**DRAFT ADDENDUM
ENGINEERING EVALUATION/COST ANALYSIS**

**RAYMARK-SHORE ROAD
STRATFORD, CONNECTICUT**

**EPA Contract No. 68-W6-0045
EPA Work Assignment No. 035-NSEE-01H3
TtNUS Project No. N0162**

July 1999

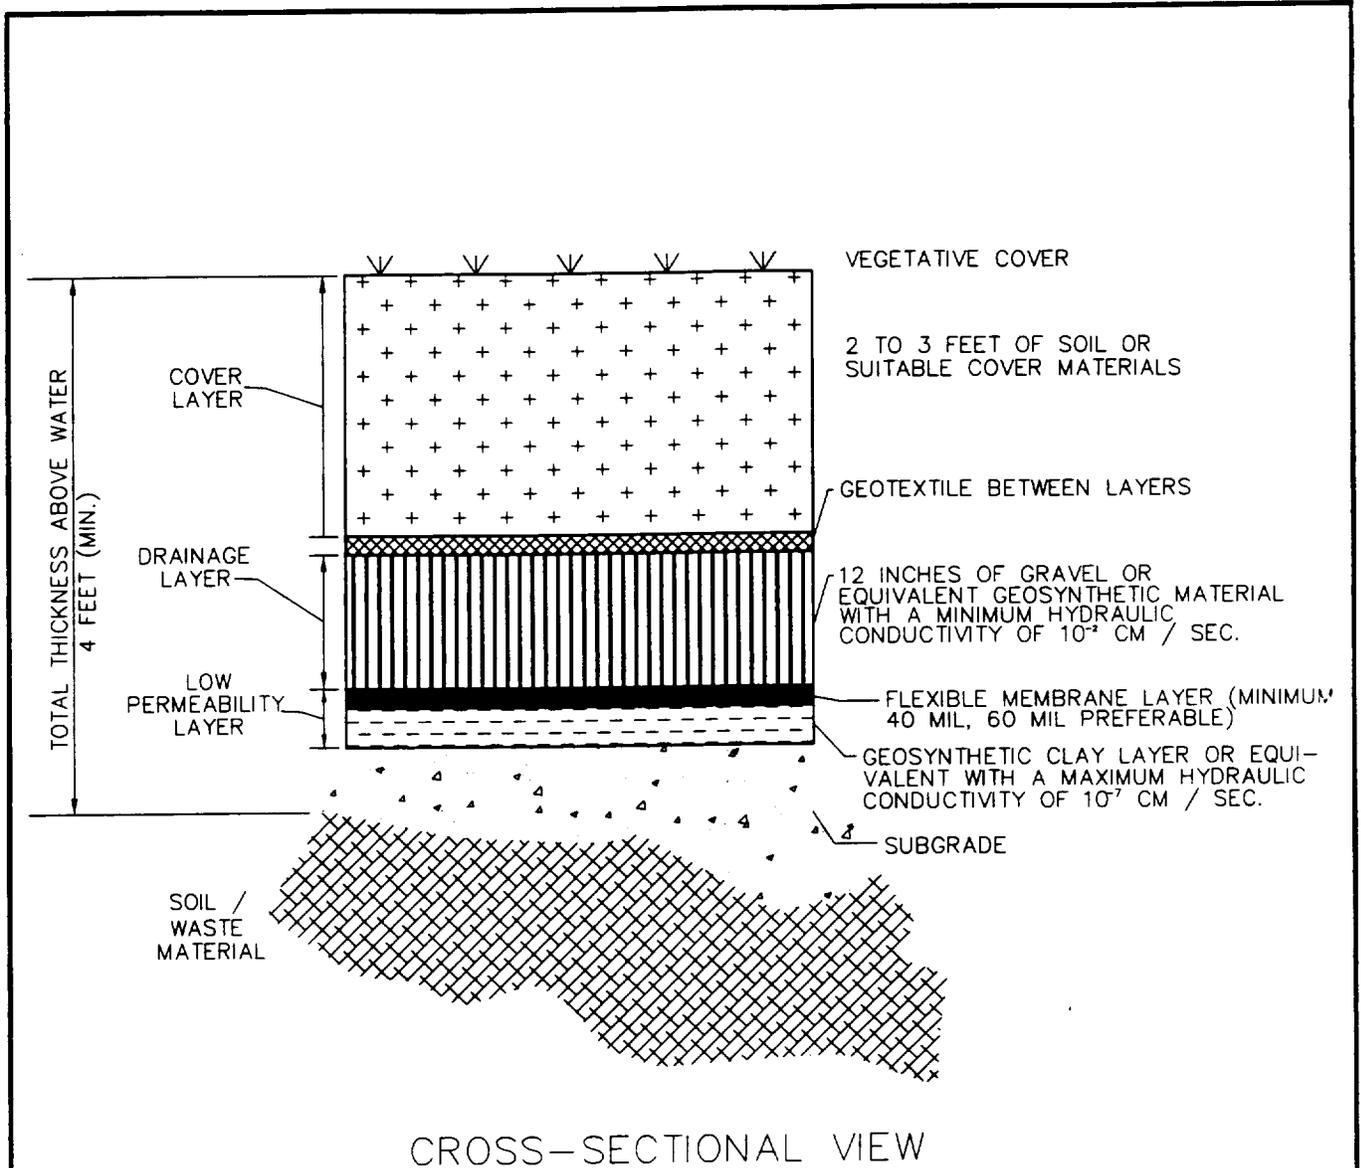
All figures and appendices referenced in the Draft Final EE/CA remain unchanged. One new additional figure, 4-2, is presented to depict the new alternative's design that was the basis for the cost figures. Table 4-1 has been revised in this Addendum to present a summary of costs for all four alternatives. No other tables have been changed.

Although not shown on Figure 4-2, a warning barrier layer will be installed within approximately one foot of the surface grade to alert a person digging to cease. The warning barrier will be a brightly colored layer such as a light permeable fabric.
